RE: Roll Tide Properties Corp. / Deer Meadows Subdivision Appeal 21-061 AP
(Appeal of File No. 21-014 SUB/TREE)

This firm represents Roll Tide Properties Corp., the Applicant in the above-referenced file. This letter sets forth the Applicant's response to the Council Staff Report for the February 22, 2021 Council hearing, which recommends denial of the Applicant's appeal and by extension, denial of the Applicant's subdivision application. The Applicant's specific objections are set forth below. For the reasons below, the Council should grant the Applicant's appeal and reverse the Planning Commission's decision.

Please note that appended to this letter is a revised subdivision concept which demonstrates how all clear and objective criteria are satisfied, including a revision to ensure that all lots have at least 20 feet of frontage to a public right-of-way. **Exhibit 1**. ORS 197.522(3) provides as follows:

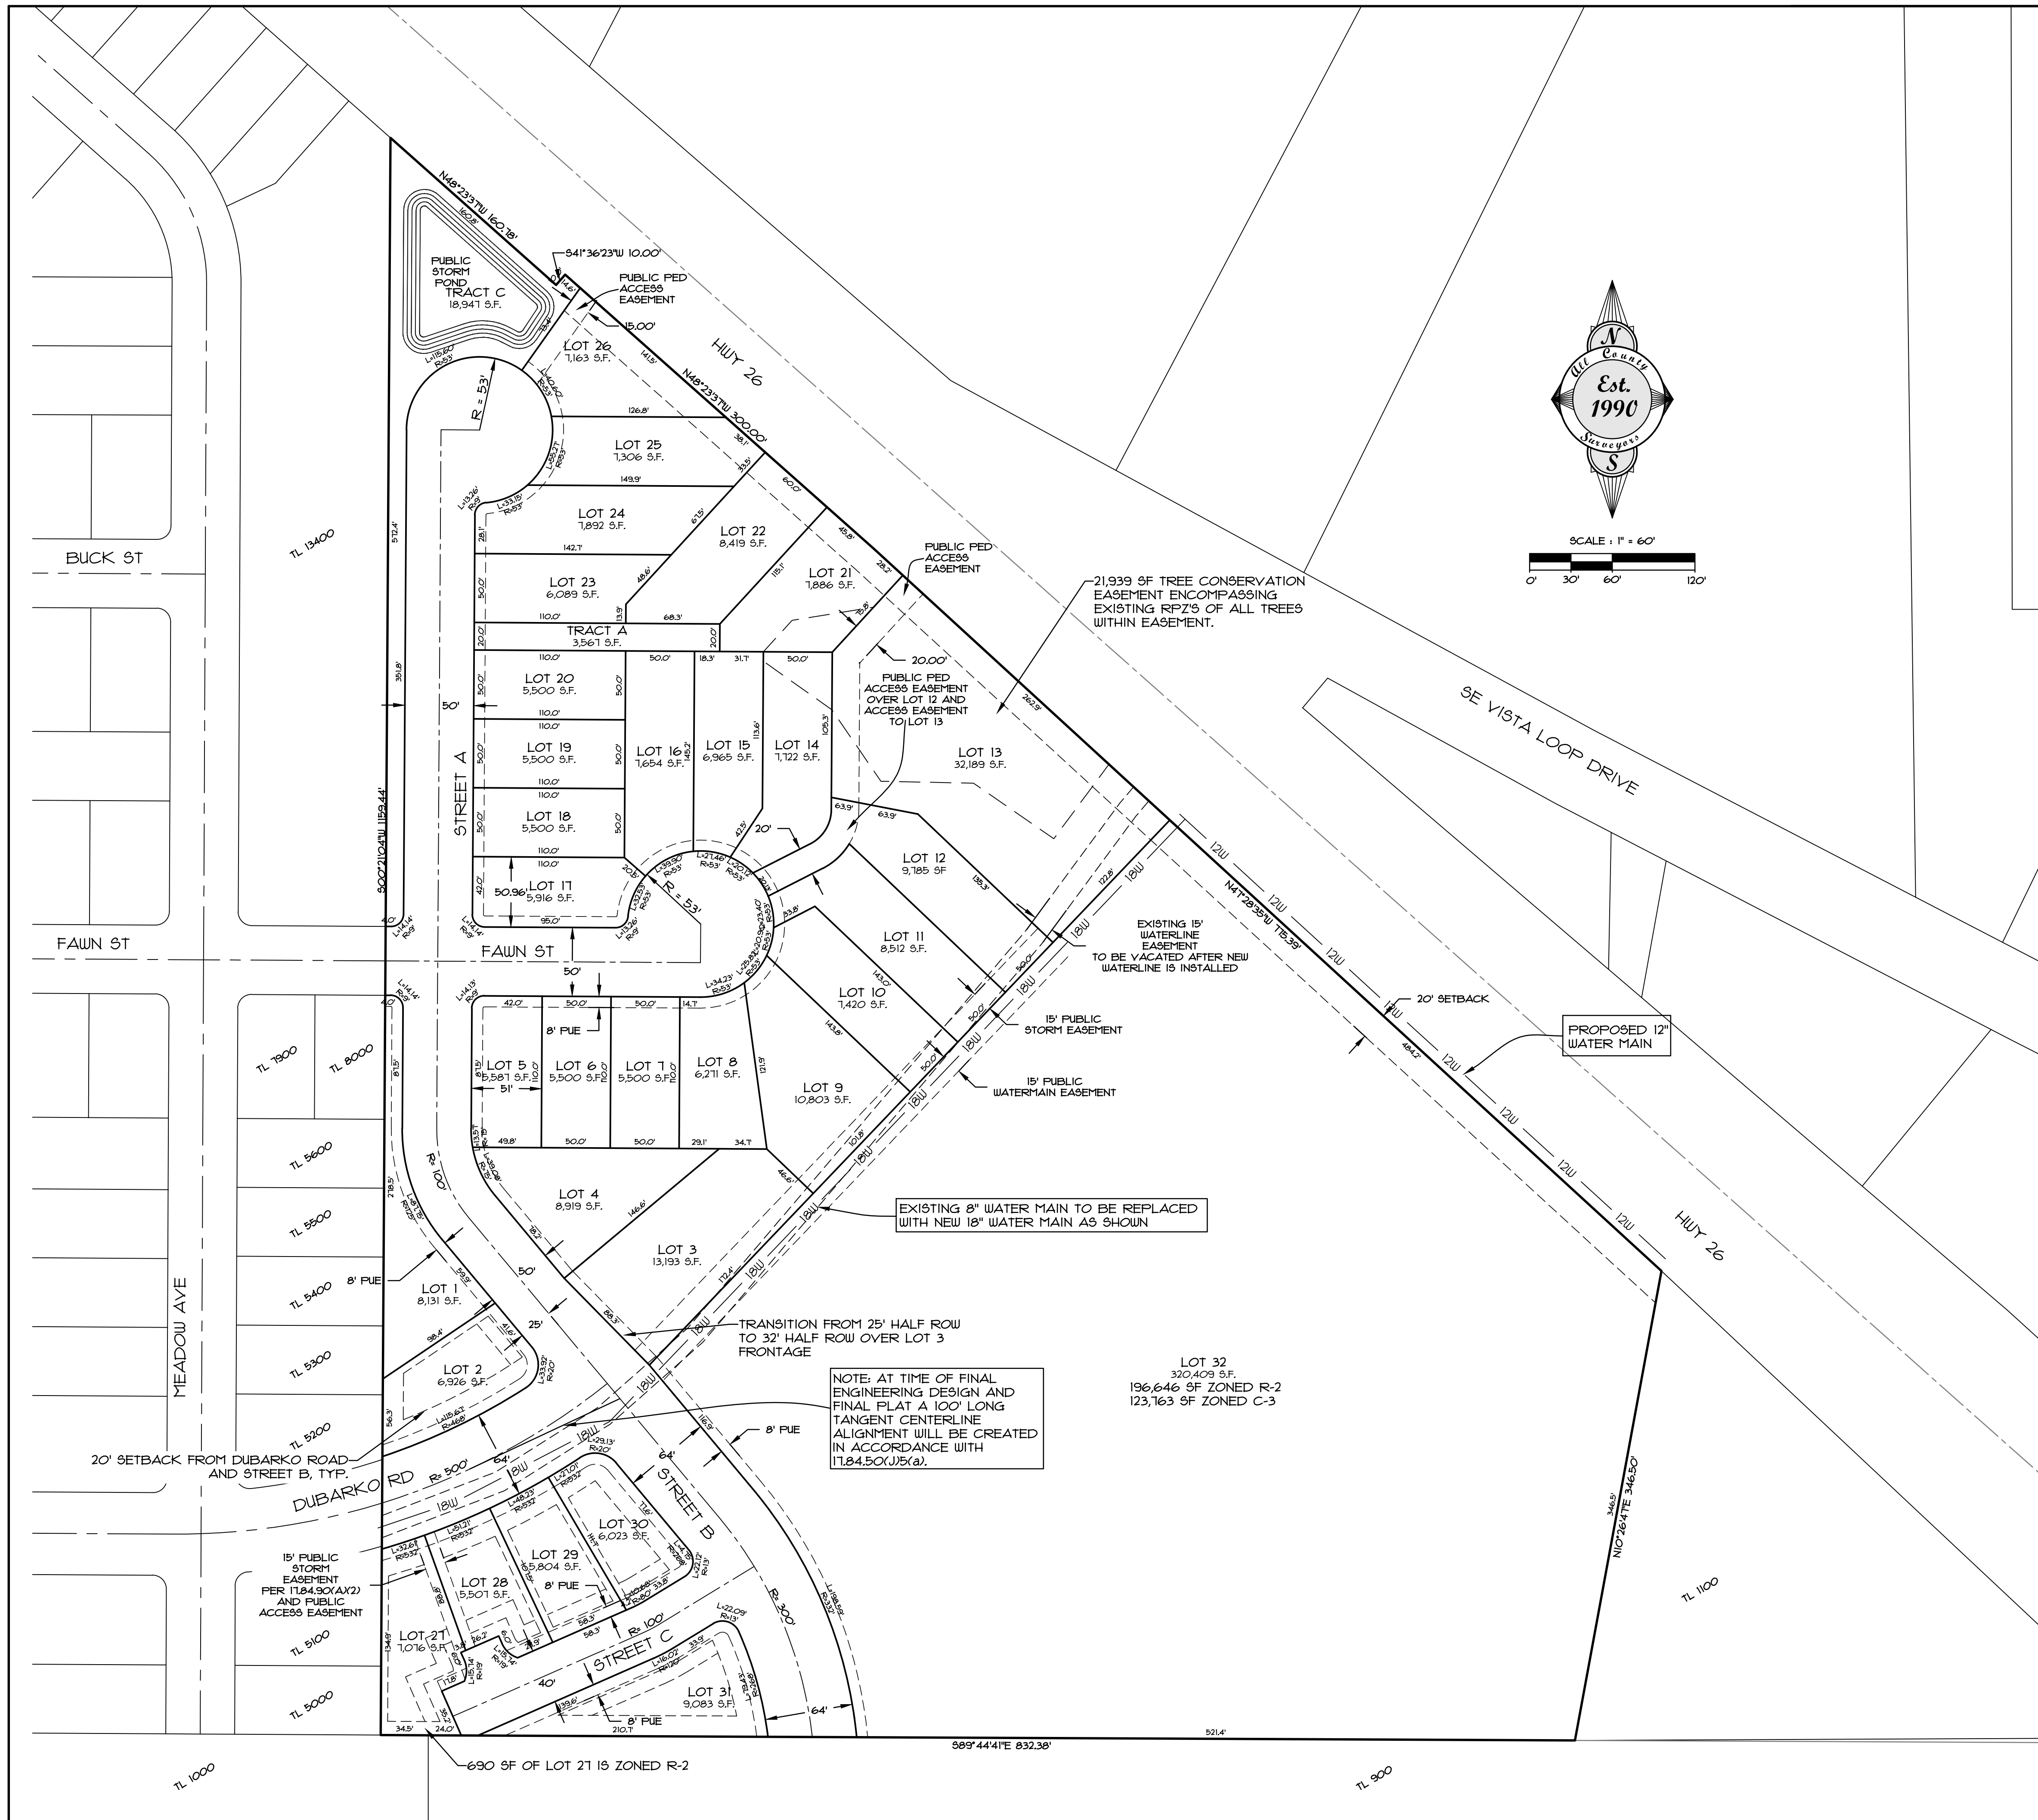
4) The Applicant proposes Lot 12 with less than the minimum 20 feet of street frontage as required by SDC 17.36.30(C).

9) The applicant's proposal does not clearly define if they propose to replace the 8-inch diameter water line and/or install an 18-inch water line in conformance with the Water Master Plan.

11) The proposed 10-foot-wide public storm drainage easements depicted between Lots 27 and 28 and at the rear of Lots 9-13 do not meet the minimum dimensional requirement for public facility easements in Section 17.84.90(A)(2).

RESPONSE: The Applicant has made a slight revision in the Application to ensure that this standard is met, as shown in **Exhibit 1**. Lot 12 now has 20.13 feet of street frontage; this standard is met. Pursuant to ORS 197.522(3), the Council should impose a condition of approval requiring at least 20 feet of street frontage as demonstrated on **Exhibit 1** to this letter.

- The above notwithstanding, **Exhibit 1** demonstrates how the Applicant can construct an 18” water line. Pursuant to ORS 197.522(3), the Applicant can satisfy this standard with the following condition of approval:

“The applicant shall install an 18-inch water line in Dubarko Rd. connected to the existing 18-inch water line at the west end of the site and the existing 12-inch line on Highway 26.”

RESPONSE: As demonstrated on **Exhibit 1**, the Applicant now proposes an increase in the 10-foot wide easement to 15 feet wide. Pursuant to ORS 197.522(3), the Applicant can satisfy this requirement by accepting the following condition of approval:

DEER MEADOWS CUL-DE-SAC EXHIBIT

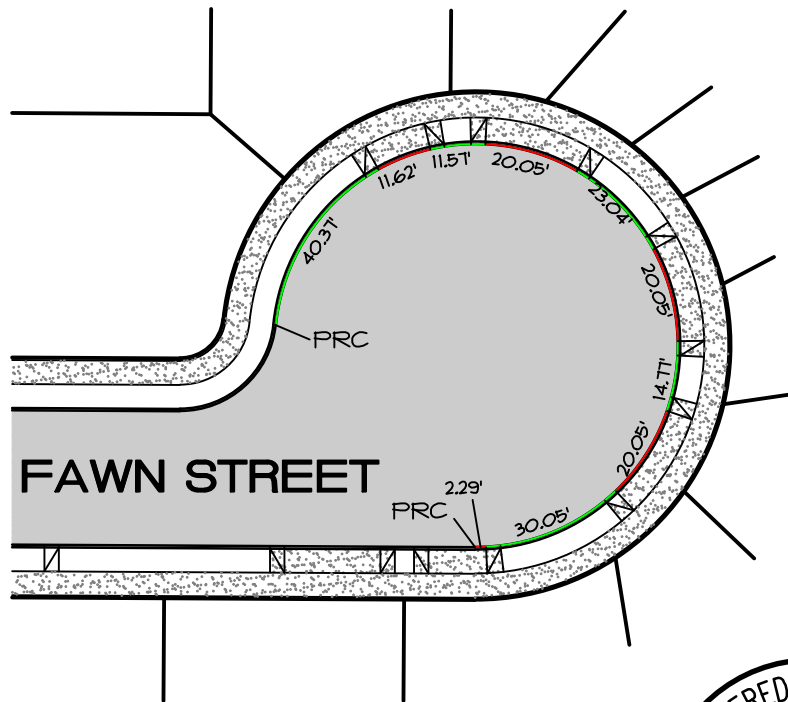
2) The applicant’s statement indicating that “Both of the proposed cul-de-sacs have less than 50% of their circumference covered by driveway drops” is not sufficient as there were no dimensional specifications submitted by the applicant to support this statement.

RESPONSE: **Exhibit 2** provides driveway width information for the Fawn Street and Street A cul-de-sacs. This exhibit demonstrates that the sum of the driveway widths for each cul-de-sac is less than 50%. SDC 17.98.100.F is satisfied.

TOTAL CIRCUMFERENCE FROM PRC TO PRC = 193.85'
 TOTAL GAPS = 119.19' (61.80%)
 TOTAL DRIVEWAY LENGTH = 74.06' (38.20%)
 (38.20% IS LESS THAN 50%. MEETS CODE)

DEER MEADOW T-INTERSECTION EXHIBIT

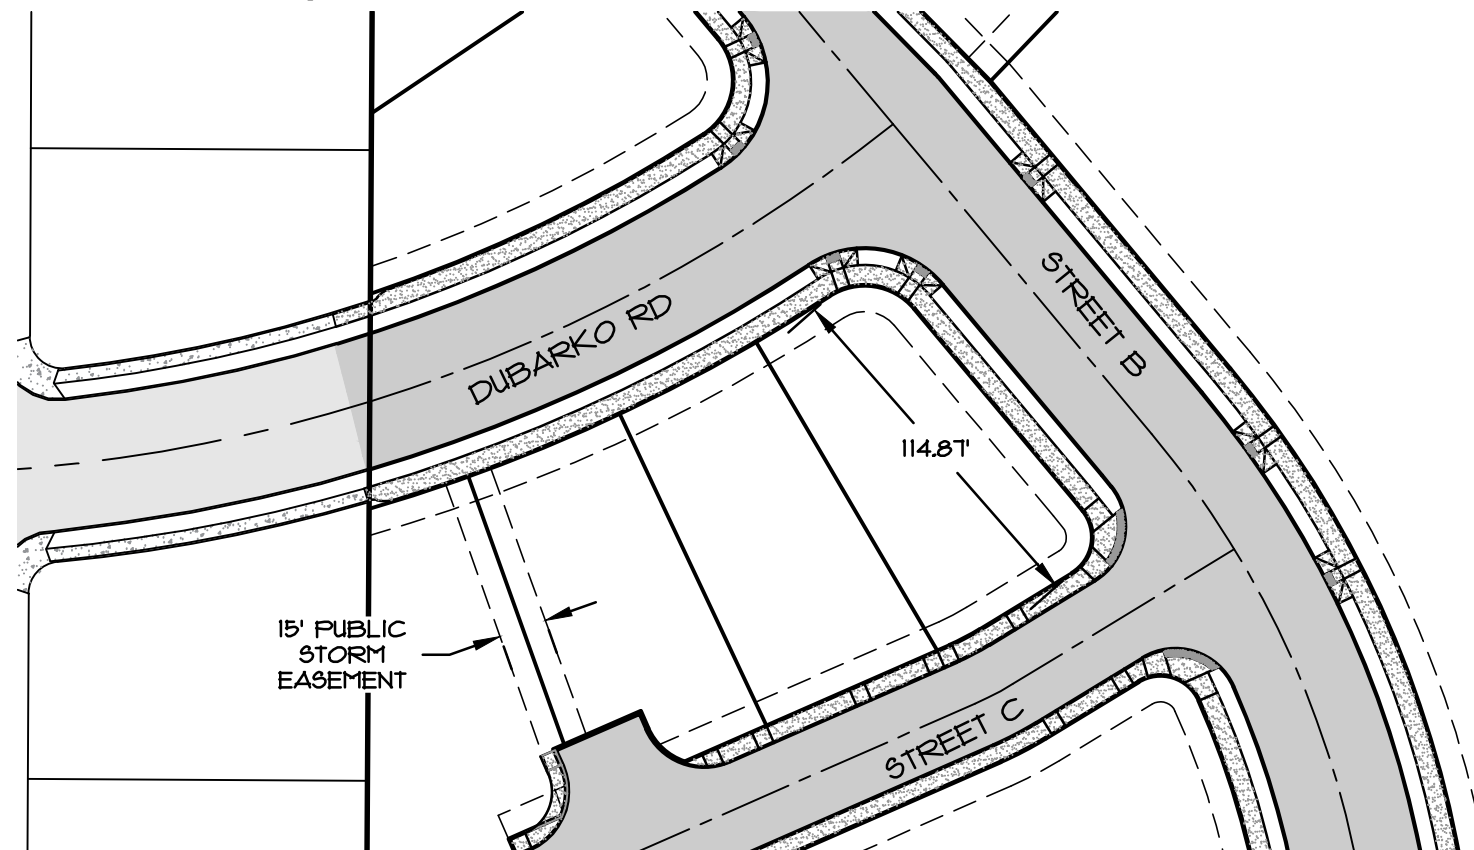
5) The distance between the two nearest edges of the right-of-way between Dubarko Road (an arterial) and Street C (a local street) is less than the minimum 150 ft. dimension in Sections 17.84.50(E)(2) and 17.84.50(J)(3).

This standard does not apply because there is no “staggered street alignment resulting in a ‘T’ intersection. First, there is no street intersection within 150 feet of the proposed termination of Dubarko Road; only a “public access lane.” Second, there are no proposed “staggered” intersections, as demonstrated in **Exhibit 3**.

PROPOSED T-INTERSECTION (NOT A STAGGERED T-INTERSECTION)

DUBARKO RD WITH 100' TANGENT EXHIBIT

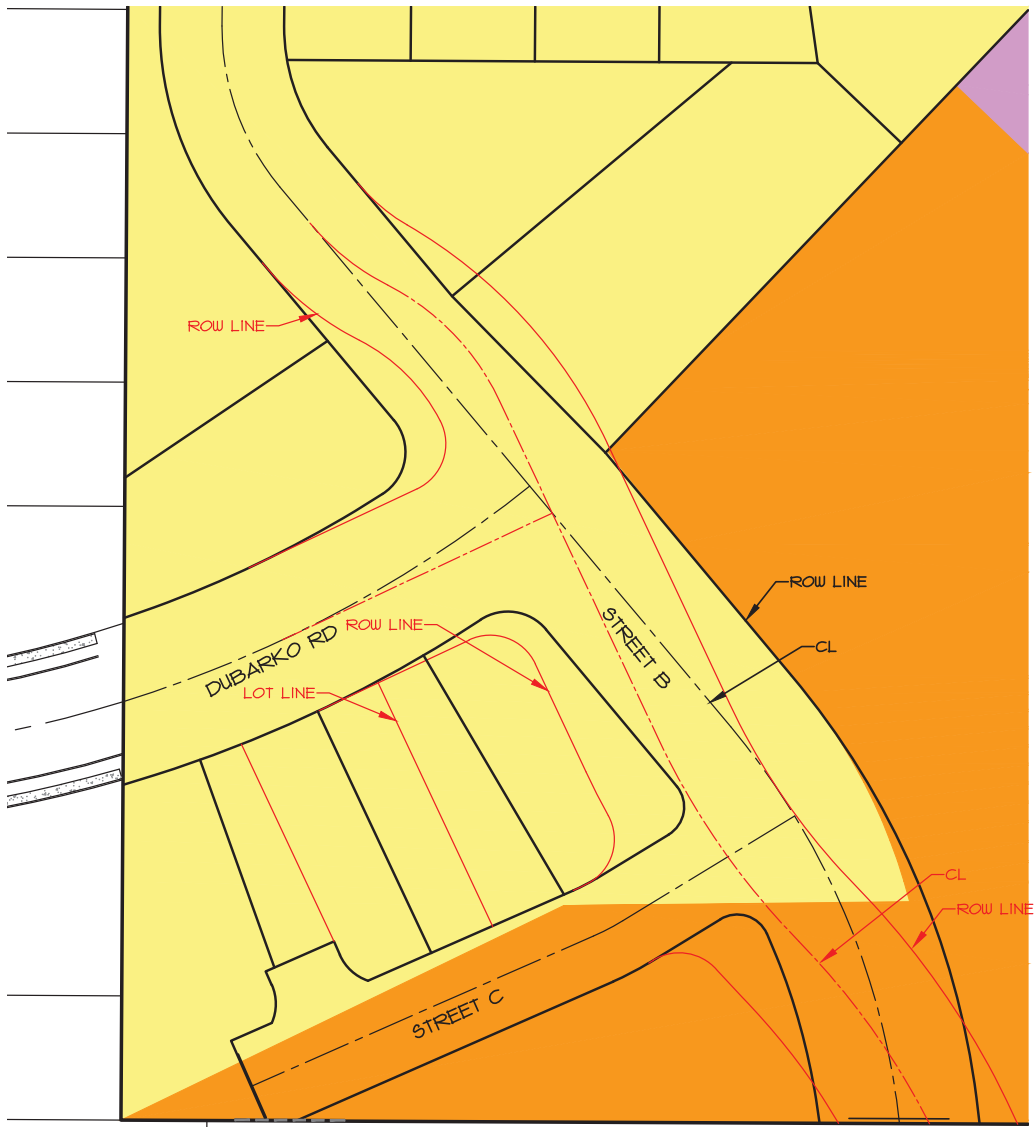
6) The minimum 100 feet of tangent alignment required in Section 17.84.50(J)5(a) is not provided at the intersection of Street “B” (a collector) and Dubarko Road (an arterial) or at the intersection of Dubarko Road and Street “B”.

“The intersection of Street B and Dubarko Road shall have a minimum of 100 feet of straight (tangent) alignment perpendicular to the intersection.”

It is feasible for the Applicant to satisfy this condition as demonstrated on **Exhibit 4**. Under ORS 197.522(3), the Council is required to impose this condition in lieu of denial because it would ensure satisfaction of SDC 17.84.950.J.5.a.

NOTE: 100' TANGENTS CAN BE PROVIDED ON STREET B AND DUBARKO AS SHOWN. THE RESULTING ALIGNMENT WOULD MAKE LOT 32 LARGER, AND ELIMINATE ONE LOT FROM LOTS 21-30.
